Commonwealth Edison

August 20, 1984

Subject: Byron Generating Station Units 1 and 2
Braidwood Generating Station Units 1 and 2
Instrumentation for the Detection of
Inadequate Core Cooling
NRC Docket Nos. 50-454/455 and 50-456/457

ICC DETECTION INSTRUMENTATION
 SENSORS, PROCESSING AND DISPLAY
 (SHEET 1 OF 2)
 FIGURE 3-1

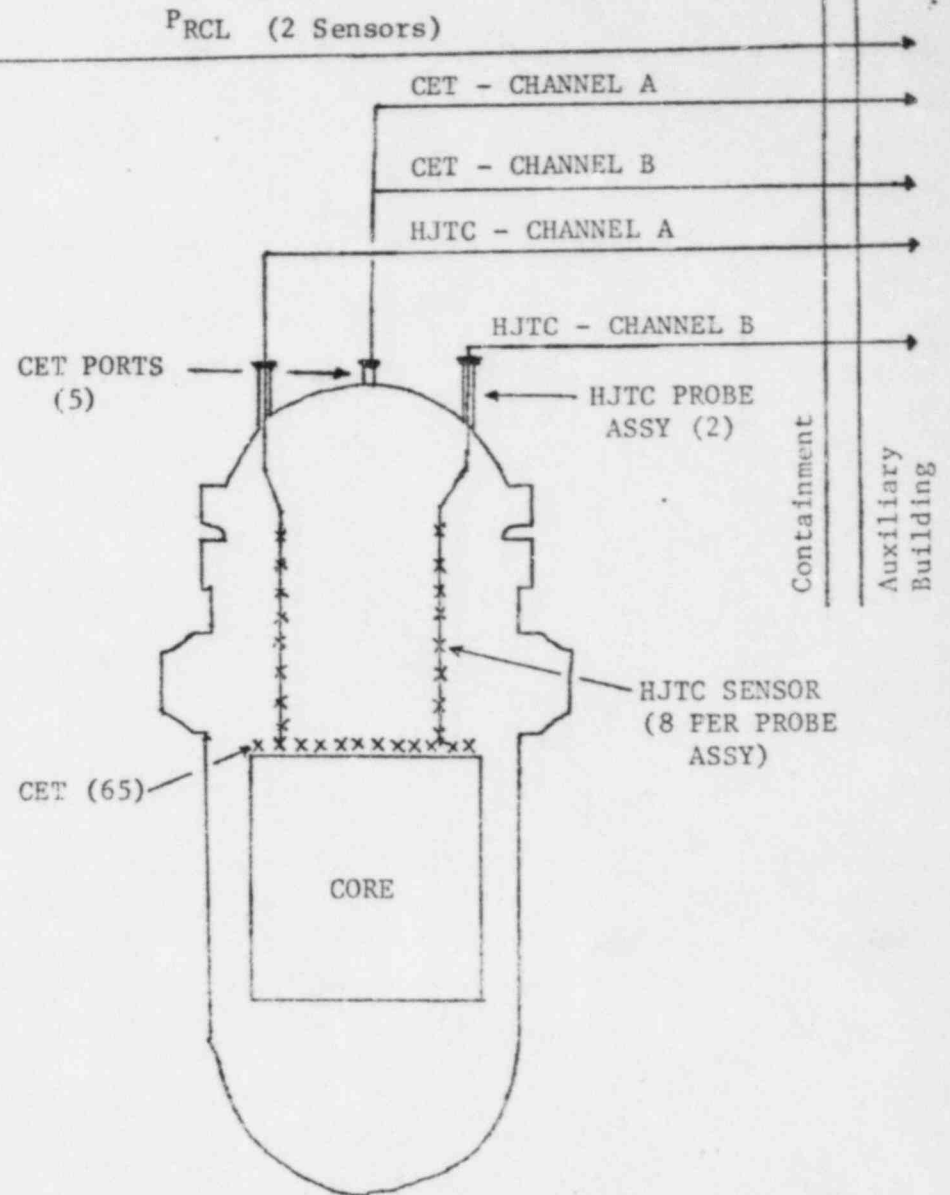
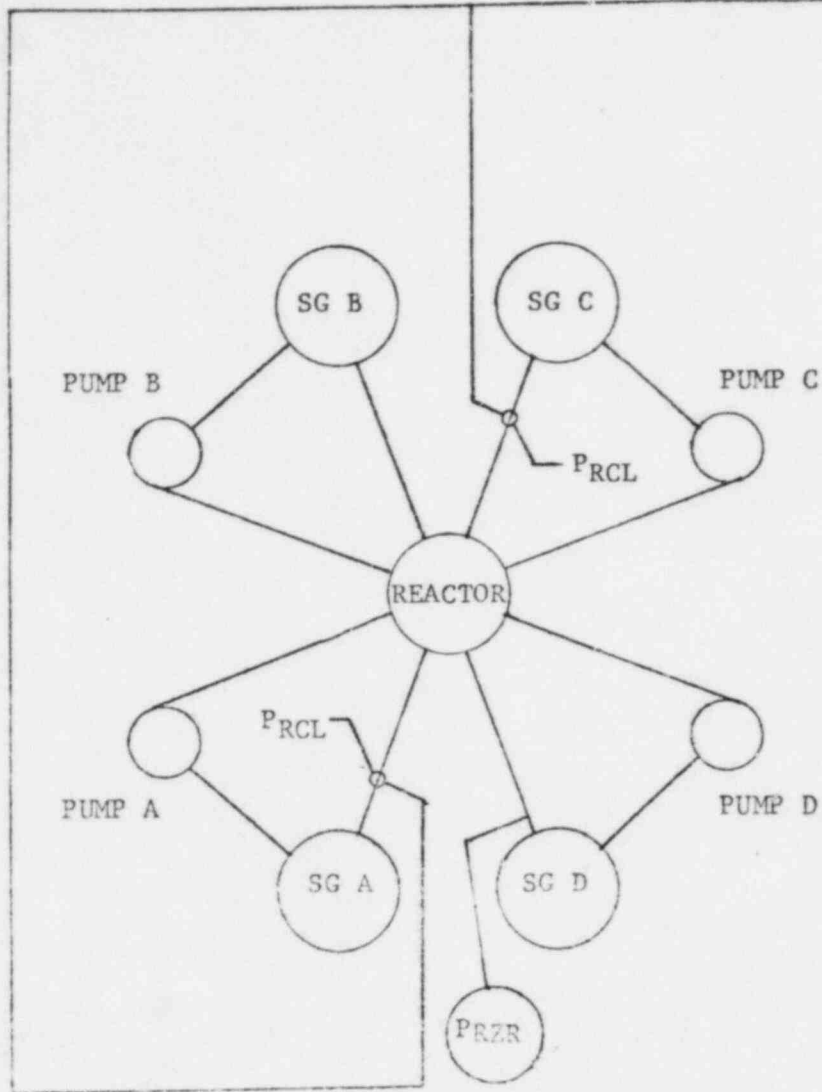
One minor correction is necessary to the information presented in reference (b) regarding display of the subcooling margin. Attachment A to that letter indicated that the subcooling would be constantly displayed on the wide range SPDS iconic. Actually, the normal display is via the narrow-range SPDS iconic. The wide range iconic is displayed after a reactor trip.

Additional information regarding various displays of subcooling is provided in Figure 3-1 enclosed with this letter. This figure is similar to Figure 3-1 in reference (a), but it contains more detail regarding the various process computer displays and instrument input signals.
